Subject: Duke Energy Carolinas, LLC (Duke Energy)
McGuire Nuclear Station, Units 1 and 2
Docket Nos. 50-369 and 50-370
Relief Request Serial # 11-MN-001, Response to Request for Additional
Information on Limited Weld Examinations for Refueling Outages 1EOC20 and
2EOC19

Relief Request 11-MN-001 Request for Additional information (RAI)

1EOC-20 and 2EOC-19 Limited Weld Exam Third interval 10 Year ISI

McGuire Flow Diagram MCFD-1554-01.02 rev 11 with weld location identified for Section 4 weld #1NV1FW53-27:

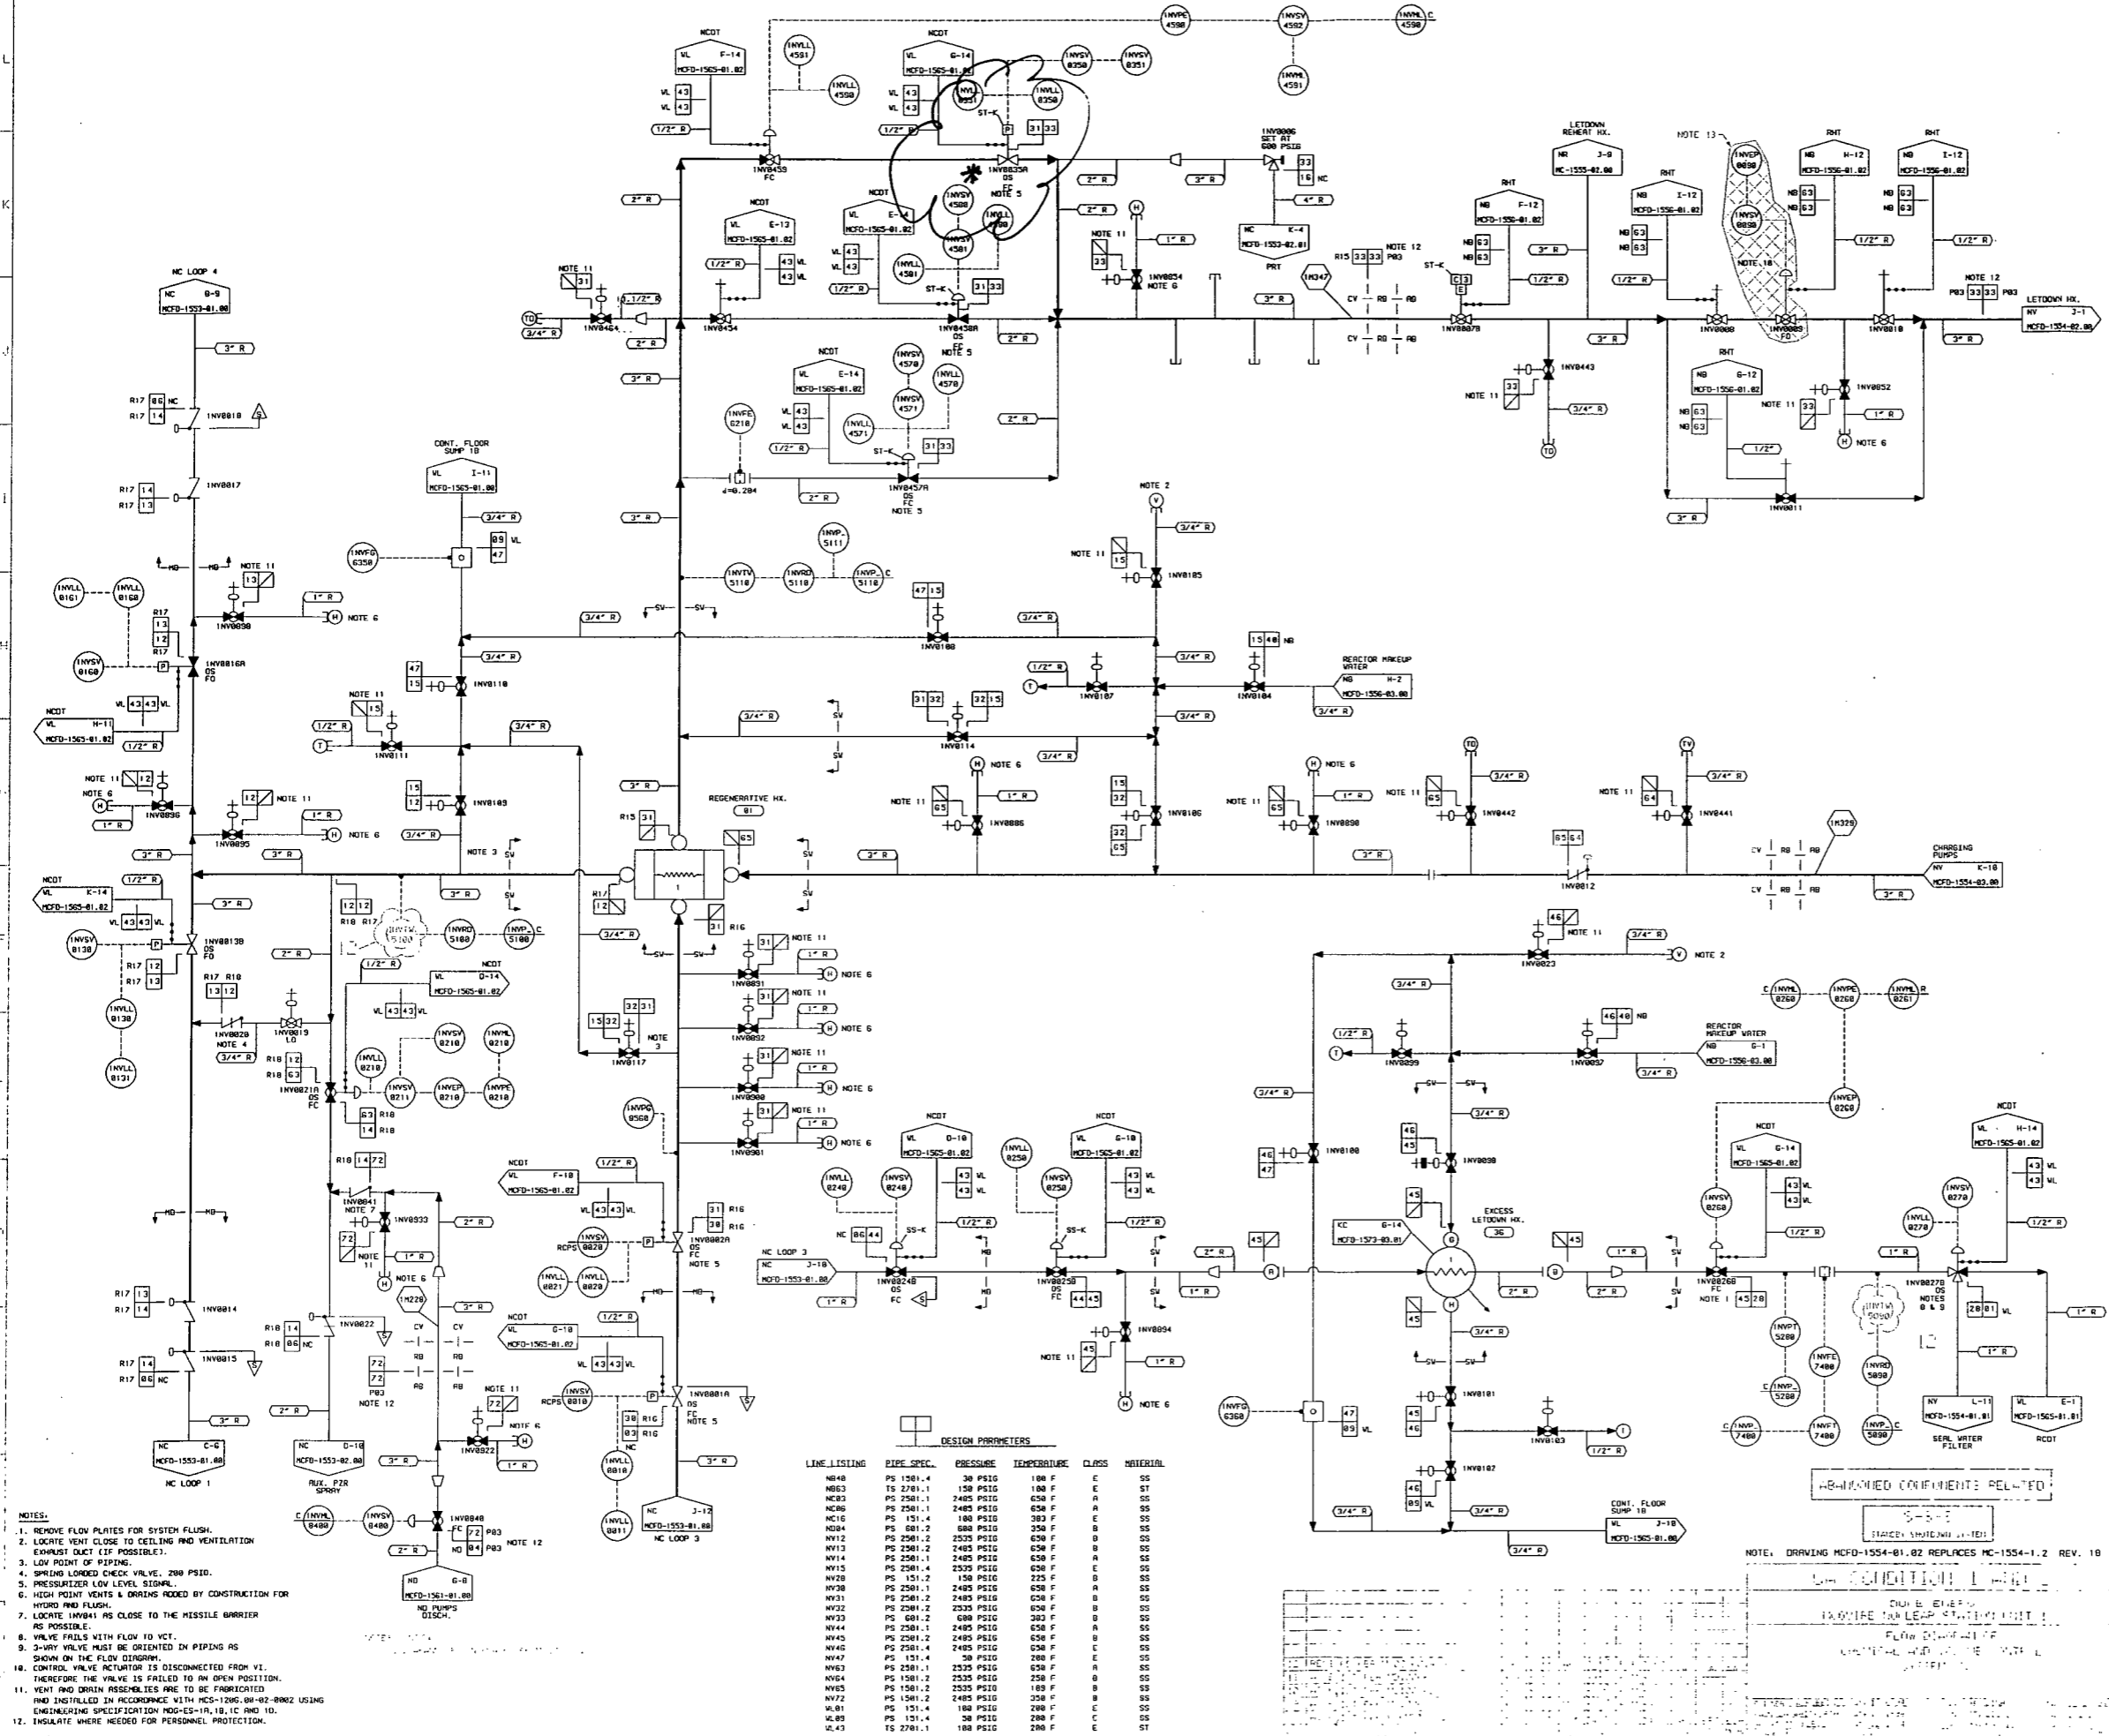
For sections 2, 4, 10, 11, 12, 13, 14, 15, 16, and 17 the components are described as being made of stainless steel. For each weld, please specify which components, if any, are made of cast stainless steel.

Duke Energy Response: The one weld associated with these sections that connects to a component fabricated from cast stainless steel is listed in Section #4 (weld #1NV1FW53-27). The specific component fabricated from cast stainless steel material (ASME SA 351 Grade CF8M) is valve 1NV-35A.
